LITTLETON WIND FARM RESPONSE TO SUBMISSIONS

**Response to Submissions Received by ACP
(ACP Ref. 324370-26)**

Document No:
P20211-FT-XX-XX-RP-PL-0003

RESPONSE TO SUBMISSIONS RECEIVED UNDER: ACP Ref. 324370-26

Addendum to Drawing No. P20-211-0600-0010, Appendix H of Appendix 8.1.

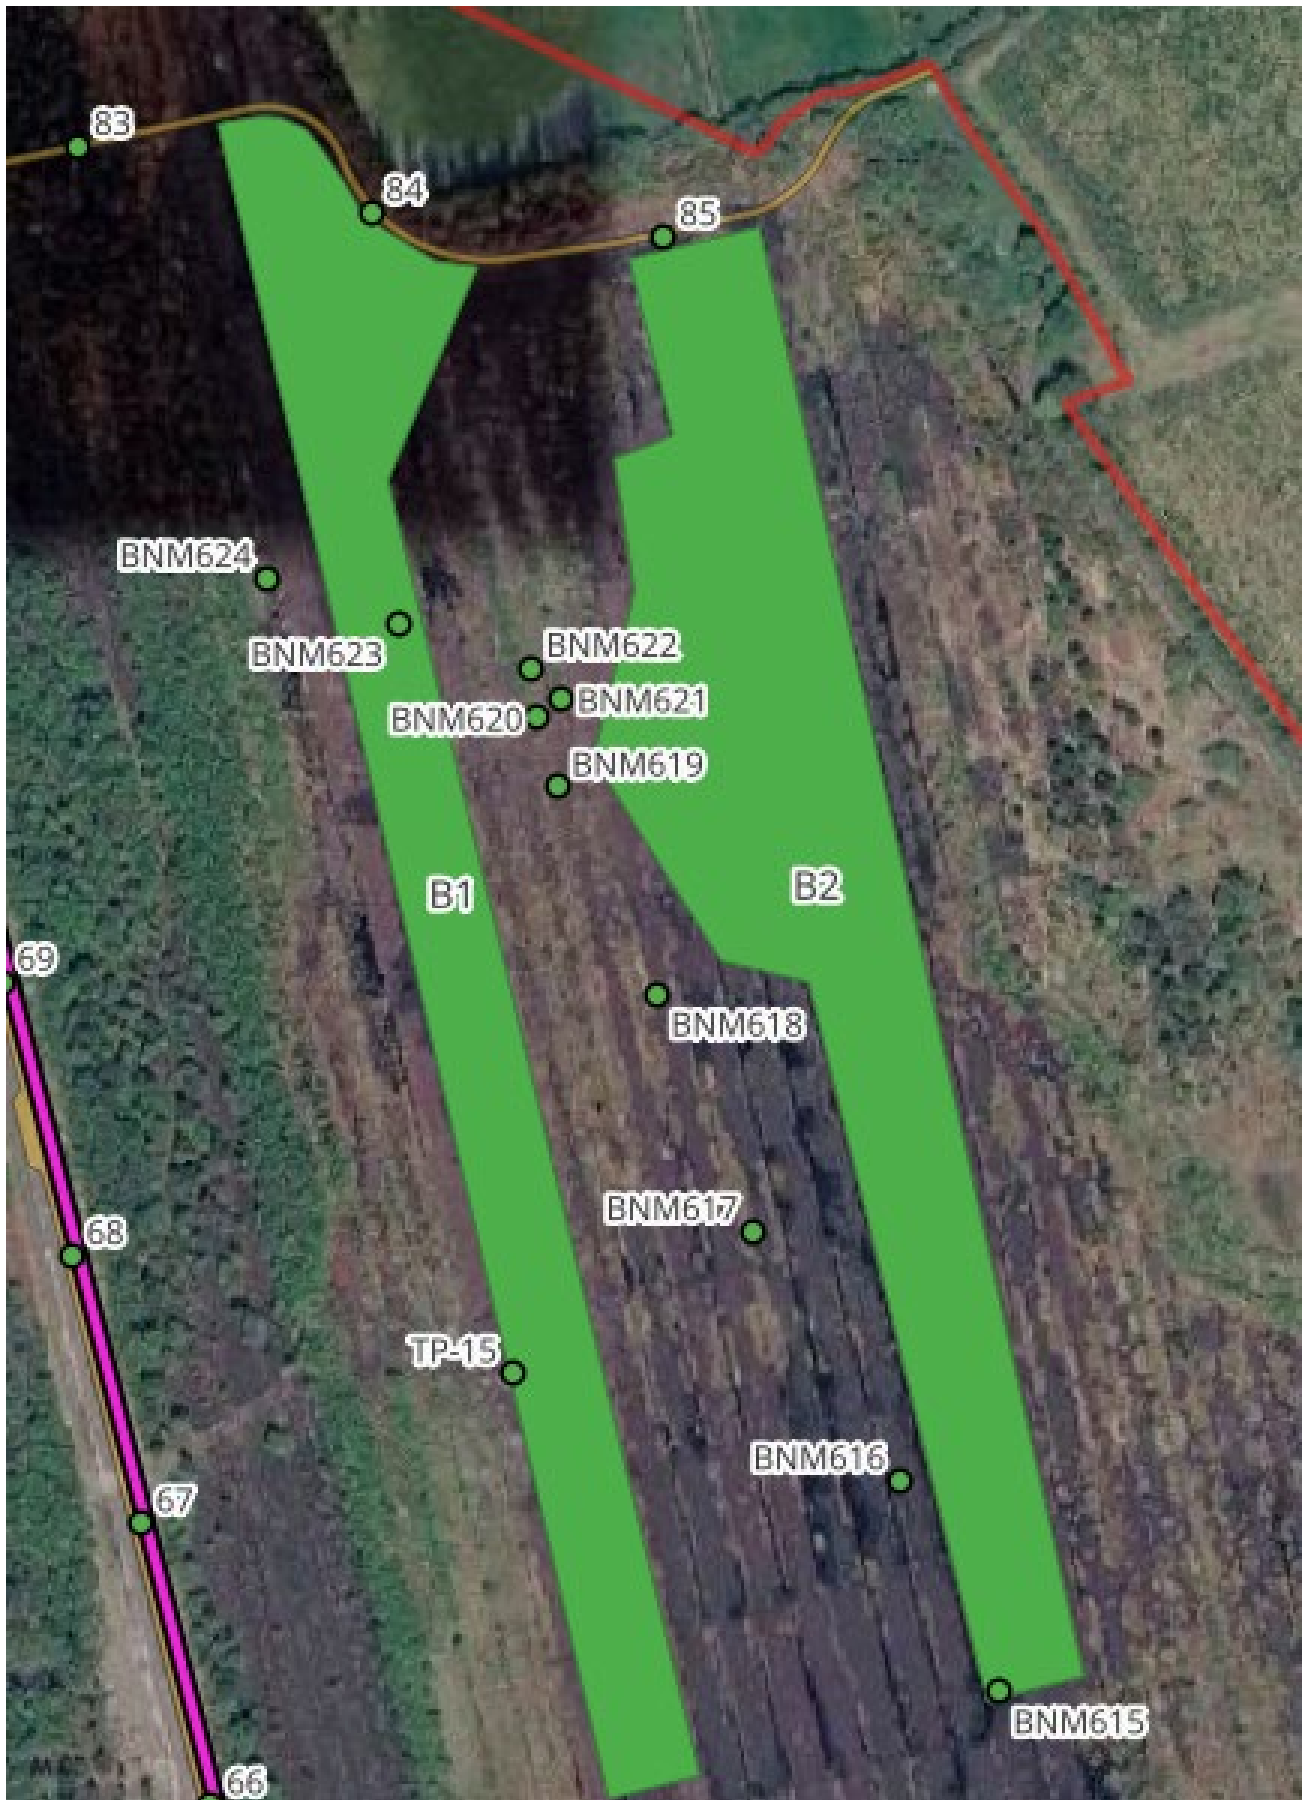
Third Party Submission	Response
<u>Peat Stability & Quality Assurance Discrepancies:</u> Submissions raise significant concerns over document-control and quality-assurance discrepancies in the Geotechnical and Peat Stability Assessment (Appendix 8.1), where summary tables (e.g., Table 7-4 for drained Factor of Safety) list turbine coordinates located far outside the Littleton site. Furthermore, Peat Repository Areas B1 and B2 record "No Information" in stability tables while simultaneously being assigned a "Negligible" risk classification. <u>Rehabilitation Trajectory & Baseline Distortions:</u> Observers submit that the EIAR improperly adopts the post-Phase 1 standard licence-compliance condition (IPC Licence Ref. P0499-01) as the complete environmental baseline without evaluating enhanced rehabilitation options. Bord na Móna documentation confirms that Lanespark was pre-emptively mapped as a constraint due to the wind farm footprint—excluding it from Phase 2 enhanced rehabilitation under the Peatlands Climate Action Scheme (PCAS) while Ballybeg and Derryvella were retained. The applicant must explain whether enhanced rehabilitation alternatives were evaluated or pre-emptively displaced by the commercial layout.	<u>Peat Stability & Quality Assurance Discrepancies:</u> We have reviewed Table 7-3 and Table 7-4 of Appendix 8.1 and notices some typographical errors in the tables . We submit that the turbines coordinates in Table 7-4 are incorrect however the Factor of Safety for Load Conditions are correct. We hereby submit as Appendix 2, and updated Table 7-4 as an Addendum to Appendix 8.1 of the EIAR showing the correct turbine requirements in the updated table. Similarly, both Table 7-3 and Table 7-4 of Appendix 8.1 omitted Condition (1) and Condition (2) of the PRA B1 and PRA B2, this has also been updated in the Addendum to Appendix 8.1 as now contained as Appendix 2 to this submission. It is important to note that these errata's do not impact on the findings of the Peat and Slope assessment stability assessment and consequential Soils and Geology impact assessment contained in Chapter 8 of the EIAR. <u>Rehabilitation Trajectory & Baseline Distortions:</u> The conditions and associated habitats created by the Phase 1 rehabilitation measures which have been implemented form part of the ecological baseline and as such form an inherent component of the baseline environment considered in the impact assessment. The impact assessment fully considers existing and emerging trends associated with the peatland rehabilitation measures that have been implemented at the Site. The rehabilitation measures relevant to the bogs within the site; Littleton (BnM, 2026a), Longfordpass (2026b) and Lanespark (BnM, 2025a) have already been implemented, and no enhanced rehabilitation measures are proposed. Phase 2 enhanced (PCAS) measures are proposed only for nearby bogs outside the site (Ballybeg and Derryvella) (BnM, 2025a).

A figure showing the Bord na Móna probe locations (addendum to Drawing No. P20-211-0600-0010, Appendix H of Appendix 8.1) together with the corresponding Factor of Safety assessment results (addendum to Appendix C of Appendix 8.1) is provided at the back of this report.

The revised coordinates in Table 7-4 have been corrected to align with the project layout presented elsewhere in the EIAR. The revised peat stability assessment results for PRA B1 and PRA B2 confirm that the peat at these locations is stable under both undrained and drained assessment conditions, with all Factors of Safety substantially exceeding the accepted minimum criterion of 1.3.
